NFPA STANDARDS DEVELOPMENT SITE SECOND DRAFT REPORT

Released Version Closing Date: February 28, 2023 NOTE: All Public Comment must be received by 5:00 pm EST/EDST on the published Closing Date.

NFPA 101®, *Life Safety Code*®, 2021 Edition

Figure A.18.2.5.7.2.3(C) For Suites >7500 ft² (>700 m²), All Sleeping Rooms Must Be Provided with Direct Supervision by Staff and Total (Complete) Smoke Detection Installed Throughout the Sleeping Suite.

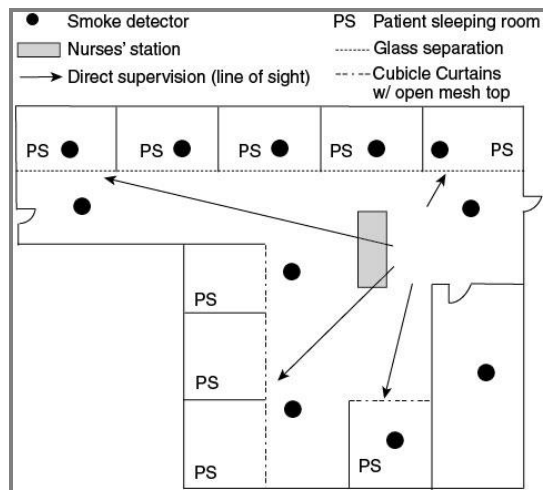
The drawing in Figure A.18.2.5.7.2.3(C) shows a smoke detector in one of the four patient rooms that have cubicle curtains with an open mesh top, while the other three rooms so not have a smoke detector shown inside the room. The smoke detector should be deleted from the one room that shows a smoke detector within to clarify that it is not needed and to be consistent with the other three patient rooms.

Figure A.19.2.5.7.2.3(B) For Suites >5000 ft² (>460 m²) and ≤7500 ft² (≤700 m²) Protected by Standard Response Sprinklers, Total (Complete) Smoke Detection Required Throughout the Sleeping Suite.

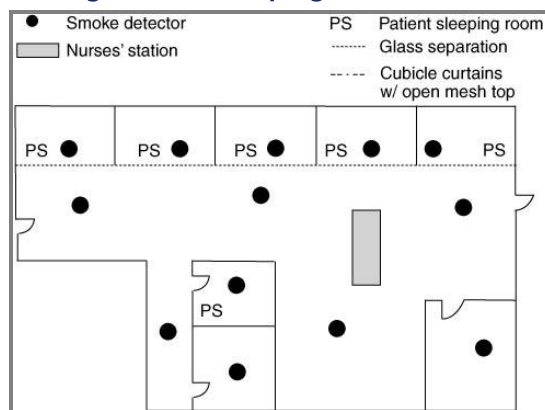
The "Cubicle curtains w/open mesh top" designation should be removed from Figure A.19.2.5.7.2.3(B) since it is not used on the drawing.

Figure A.18.2.5.7.2.1(B) All Sleeping Rooms Provided with Either ~~with~~ Direct Supervision by Staff or Smoke Detection.

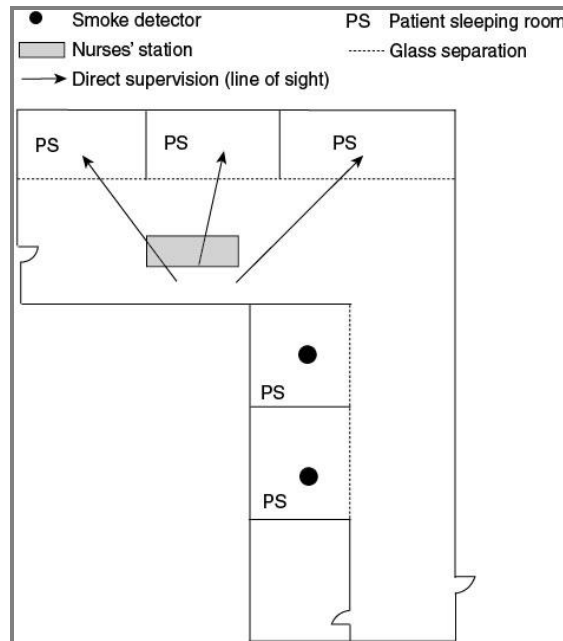
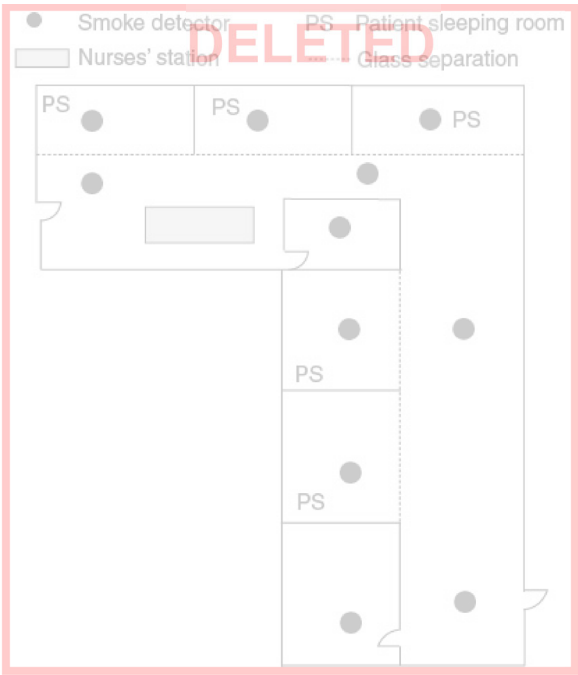
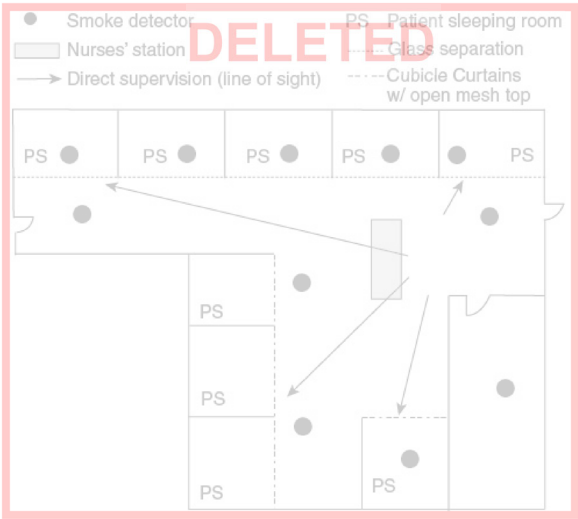
- (1) Direct supervision of all sleeping rooms by staff from a normally attended location within the suite [in accordance with 18.2.5.7.2.1(B)(1)(a)]
- (2) Supervision of those sleeping rooms that can be directly supervised [in accordance with 18.2.5.7.2.1(B)(1)(a)] and smoke detection provided in the sleeping rooms that cannot be directly supervised [in accordance with 18.2.5.7.2.1(B)(1)(b)] as depicted in Figure A.18.2.5.7.2.1(B)

~~Total (complete) coverage smoke detection throughout the sleeping suite [in accordance with 18.2.5.7.2.1(B)(2)] as depicted in Figure A.18.2.5.7.2.1(B)(b)~~
